Re: CDS21001761 pre-connection enquiry - Subject to contract | Contract denied

Connection for Multi/Mixed Use Development of 450 unit(s) at Lands at Kilanhue Lane, Gorey, Co. Wexford

**Re: Design Submission for Lands at Kilanhue Lane, Gorey, Co. Wexford (the “Development”)
(the “Design Submission”) / Connection Reference No: CDS21001761**

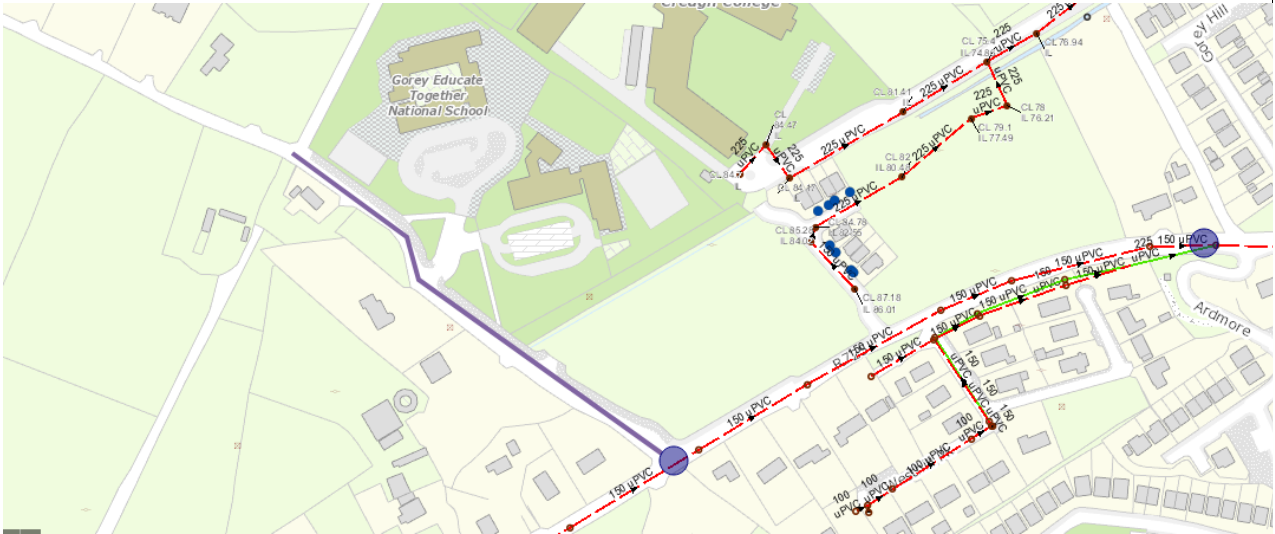
The nearest foul sewer is approximately 310m from the proposed development. A sewer extension would be required to service the proposed development with the costs borne fully by the developer. A further 325m approx. of existing DN150 sewer on R725 will need to be upsized.

IW have undertaken a review of the impact this development will have on the wastewater network downstream. 611m approx. of sewer in Gorey town centre would need to be upsized to cater for this new development.

- 345m approx. of DN225 to be upsized to DN375 in Main Street
- 189m approx. of DN225 to be upsized to DN375 in Esmonde Street
- 77m approx. of DN525 to be upsized to DN750 in Courtown Road

Irish Water will require you to provide a contribution of the relevant portion of the costs for the required upgrades, please contact Irish Water to discuss this further.

Sewer network adjacent to the site. 310m approx. sewer extension and 325m approx. of upsizing the existing DN150 on the F725 indicated by the section between the two circles.

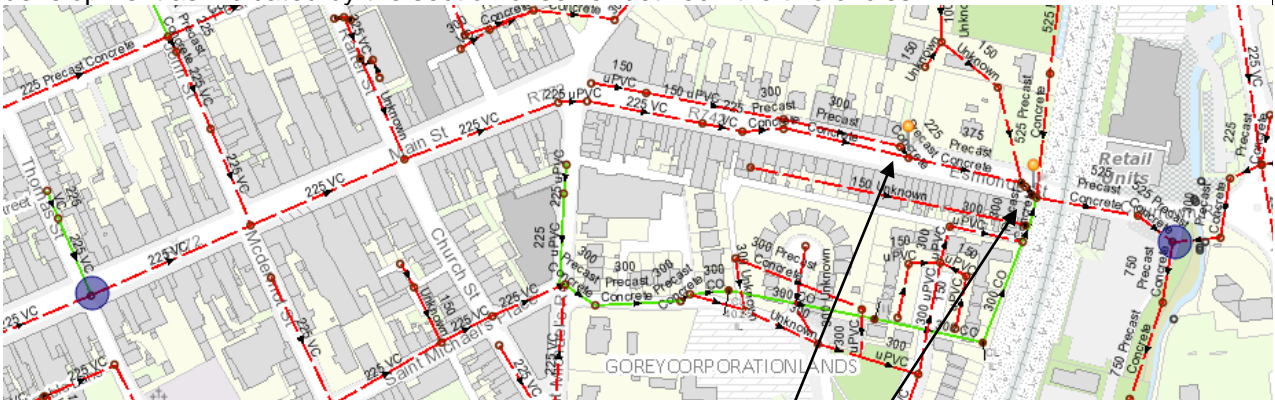
611m approx. of sewer in Gorey town centre would need to be upsized to cater for this new development as indicated by the section of sewer between the two circles.

The 70m of existing DN375 sewer to the eastern end of Esmond Street does not need to be upsized

Option 1. Model-GIS Screenshot of Preferred Solution: Upsizing of Existing Gorey Hill Booster Station

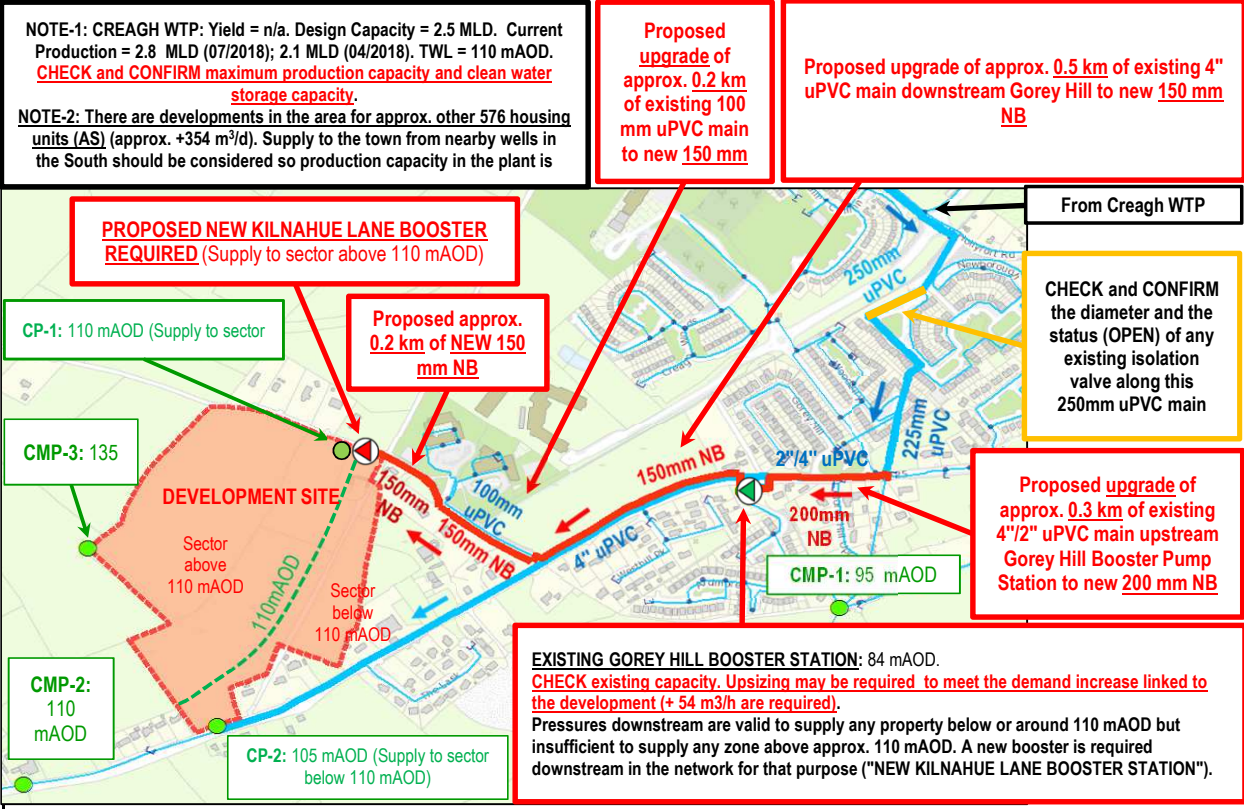
NOTE-1: Creagh WTP: Yield = n/a. Design Capacity = 2.5 MLD. Current Production = 2.8 MLD (07/2018); 2.1 MLD (04/2018). TWL = 110 mAOD. **CHECK and CONFIRM maximum production capacity and clean water storage capacity.** **NOTE-2:** There are developments in the area for approx. other 576 housing units (AS) (approx. +354 m³/d). Supply to the town from nearby wells in the South should be considered so production capacity in the plant is made available for developments.

UPSIZING OF EXISTING GOREY HILL BOOSTER STATION: 84 mAOD.

- EXISTING SET OF PUMPS to supply the same areas as now and a small part of the development (sector below 110 mAOD). **CHECK** existing maximum capacity.
- A NEW SET OF PUMPS is required to supply most of the development (sub-sector above 110 mAOD). A new 150 mm NB rising main is required for that purpose. **CHECK availability of space for this expansion.** Otherwise, an alternative solution is provided in Page 2.

Does development adversely impact existing customers?	YES. Pressures below are model-based pressures. Values between brackets correspond to pressures without the development. Values outside of the brackets correspond to the situation whether the development would be supplied through the existing network.		
Min. Press. at Connection Point (CP)	CP-1: n/a	CP-2: 14 m (32 m)	
Minimum Pressure at CMP	CMP-1: 10 m (12 m)	CMP-2: 9 m (27 m)	CMP-3: n/a
Maximum Headloss Supply Main	Between 7 and 10 m/km along the 2 1/4" uPVC shown above.		
Is Development Feasible?	Network Upgrades Required
